License No. NPF-3  
Docket No. 50-346  
Serial No. 988  
September 26, 1983

This is in response to your letter dated August 8, 1983, (Log No. 1342) concerning steam generator blowdown system containment isolation valves. The attachments provide Toledo Edison's response for additional information for Davis-Besse Nuclear Station No. 1.

ATTACHMENT 1 TO TOLEDO EDISON LETTER  
ON STEAM GENERATOR BLOWDOWN SYSTEM

ATTACHMENT 2

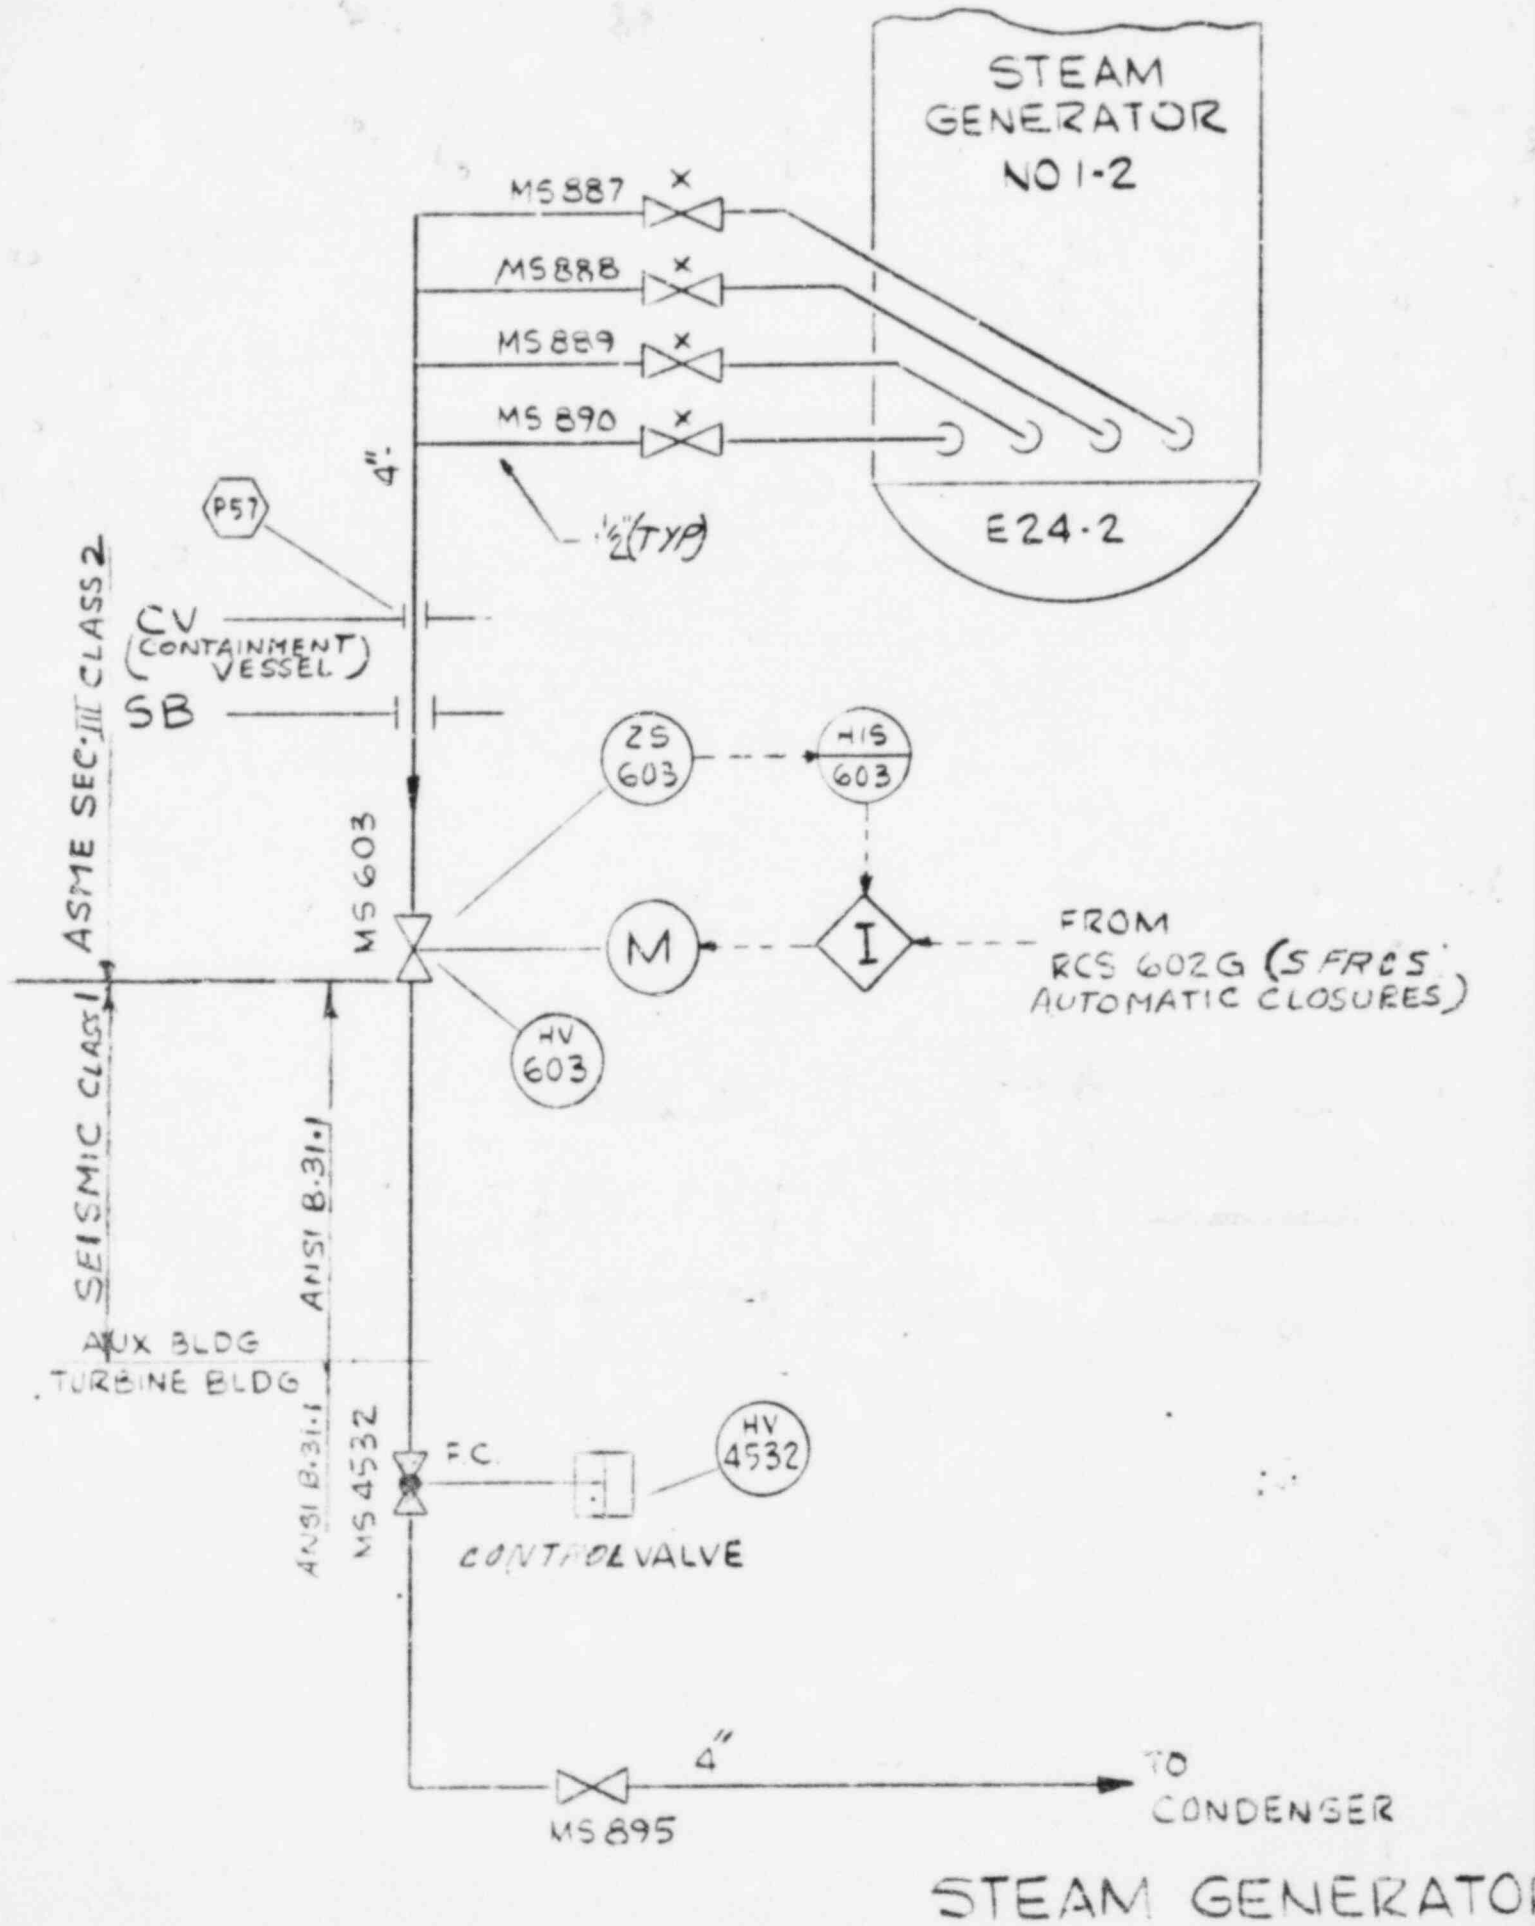
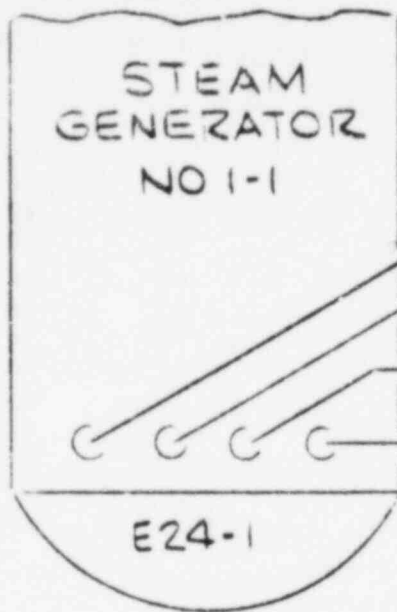
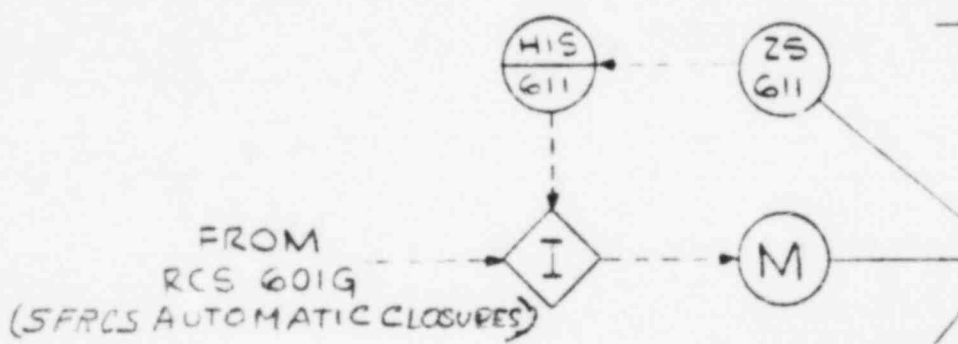
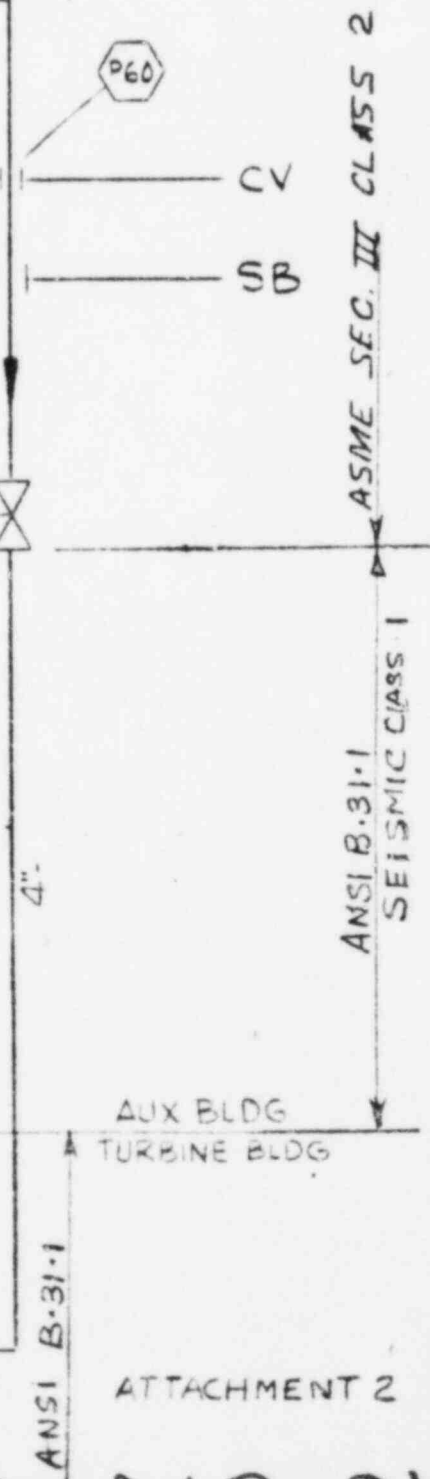
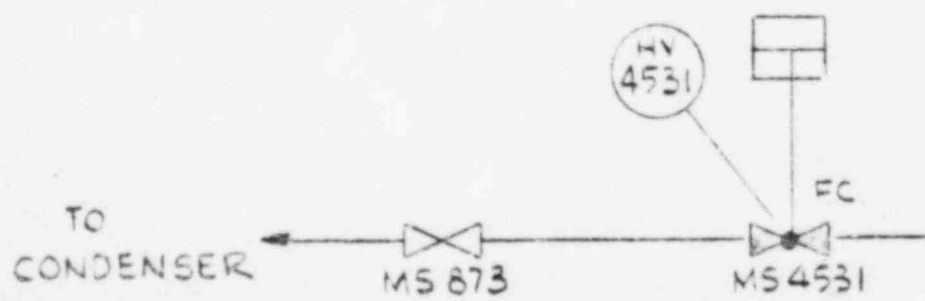
Item b. Provide a complete description of the blowdown system from the steam generator to the condenser. A one line diagram such as a P&ID will be adequate.

Response b. A simplified P&ID of the steam generator blowdown system is shown on the Attachment 2. The steam generator blowdown system (SGBS) piping and valves from the steam generator through the containment penetration and out to the containment isolation valve are designed to the requirements of ASME Section III, Subsection NC (Class 2). That portion of the system from the first circumferential butt weld inside the containment out to, and including, the isolation valve (including the flued heads) is also designed to the requirements of Subsection NE (Class MC). The remaining portion of piping in the auxiliary building is designed to ANSI B31.1 and is seismic Class 1. The piping and valves in the Turbine Building are designed to the requirements of ANSI B31.1. The new design will provide an automatic steam and feedwater rupture control system (SFRCS) closure signal to the blowdown system valves MS 603 and MS 611. The actuation of SFRCS in the event of loss of feedwater, steam line break, or feedwater line break will isolate the steam generators. In addition, blocking capability of SFRCS signals to these valves will be provided in the control room. It will enable the operator to manually open these valves to provide a steam generator drain path to the condenser to provide steam generator level control in case of a steam generator tube rupture accident.

JOB NO	DRAWING NO	REV NO
7749	M-207A	5
DCN NUMBER		
M-207A-2		
CONTINUATION SHEET		
PAGE 2 OF 2

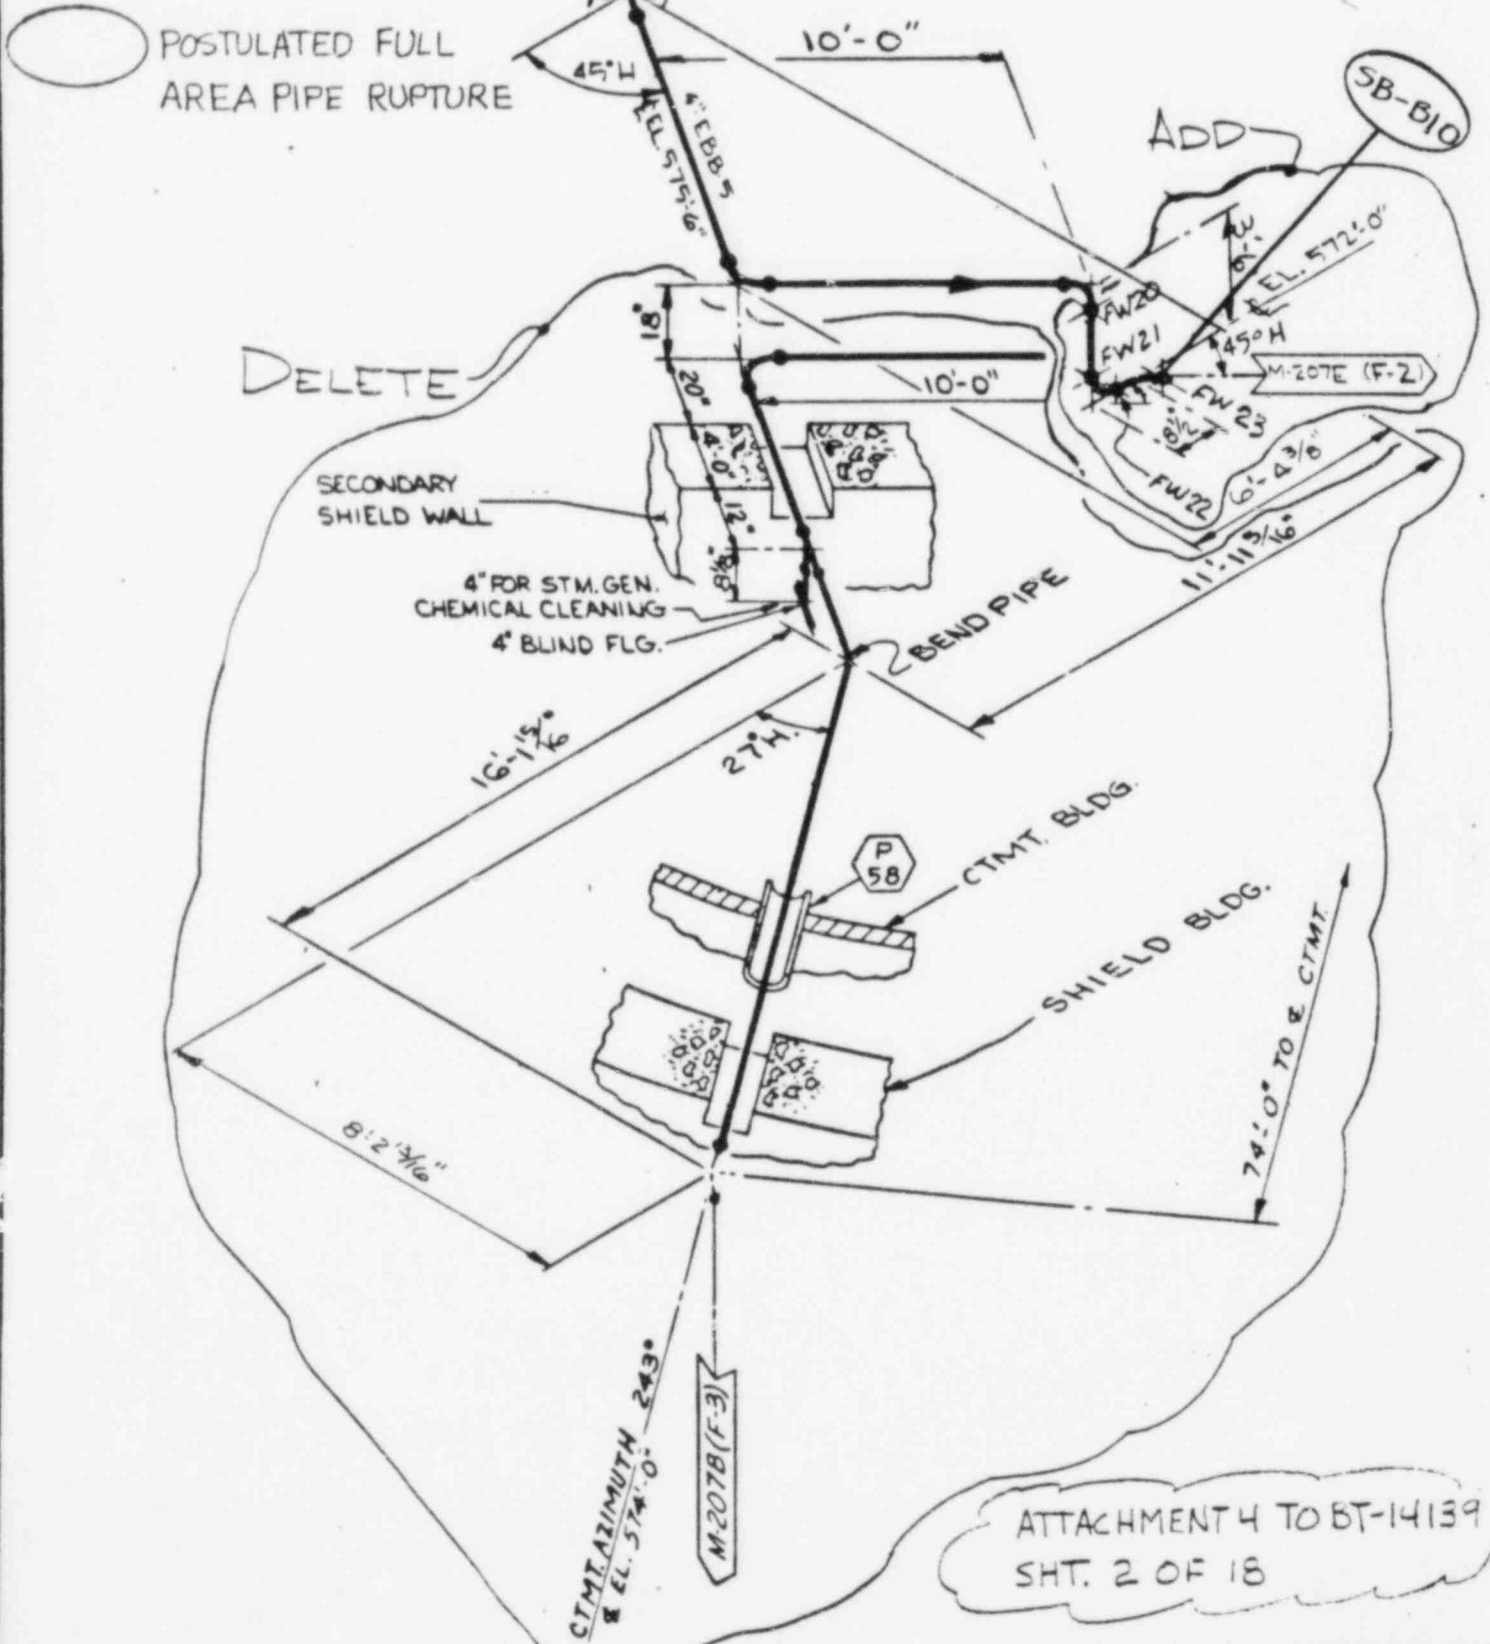
Attachment 4 (Sheet 1 through 18) are included to indicate selected pipe rupture locations in accordance with SRP 3.6.2. The break locations are designated by the prefix SB.

<u>Figure</u>	<u>Postulated Break Point</u>	<u>Stress (PSI)</u>
M-207A (DCN)	SB-50	24,700
	SB-140	15,599
	SB-B10	20,567
M-207E	SB-5E	29,570
	SB-320	19,456
	SB-80	31,635
	SB-110	21,640
M-207F	SB-72	6,520
	SB-170	17,912
	SB-120	31,154
	SB-130	30,999
M-207G	SB-5	29,901
	SB-220	25,315
	SB-190	7,895
	SB-45	33,891
	SB-60	25,725
